THE ROVER COMPANY LIMITED

LAND-ROVER SERVICE NEWS LETTER Vol. 2 No. 16

January 1967

Fig. 1 Modification to gearchange selector levers
 A—Slot $\frac{1}{8}$ in. (1.5m.m.) x $\frac{5}{32}$ in. (4,0 m.m.)

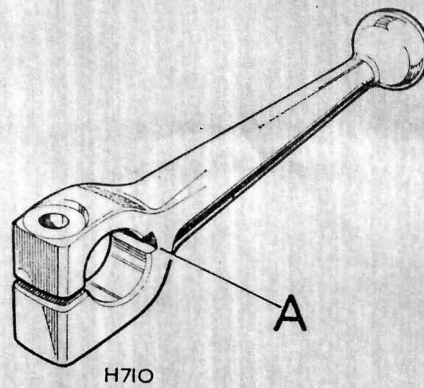
REMARKS: Occasional difficulties have been experienced in clamping the selector levers rigidly to their respective selector rods.
Where the clamping action is found to be insufficient, the grip can be increased by cutting a slot $\frac{1}{16}$ in. (1,5 mm) wide and $\frac{5}{32}$ in. (4,0 mm) deep in the lever, directly opposite the saw cut. If possible the slot should have radiused corners.
